MANDATORY SERVICE BULLETIN NO. MSB 62-035

Type: DA 62

Installation of bonding cables.

WORK INSTRUCTION WI-MSB 62-035

Figure 2. Suppressor plate seen looking forward into the nacelle through the aft access panel.

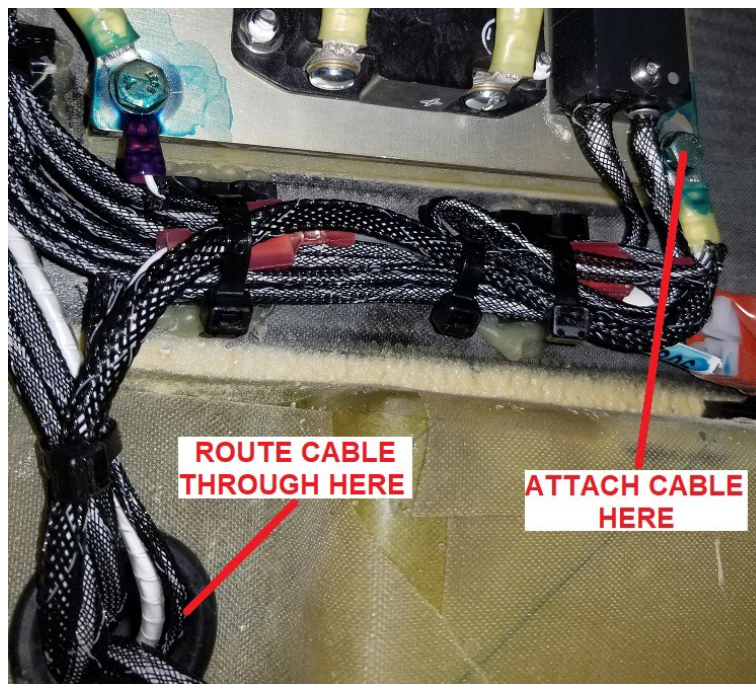
4. Install the end of the bonding cable with item 2 to the location shown in Figure 2, i.e. the smaller ring terminal attaches to the suppressor plate. Use Nycote 7-11 blue.
5. Route the bonding cable through the grommet shown in Figure 2.
6. Install the other end of the bonding cable to the location shown in Figure 3. Use Nycote 7-11 blue.
7. If there is excess length in the bonding cable, tie it into a bundle.
8. Install the access panels.
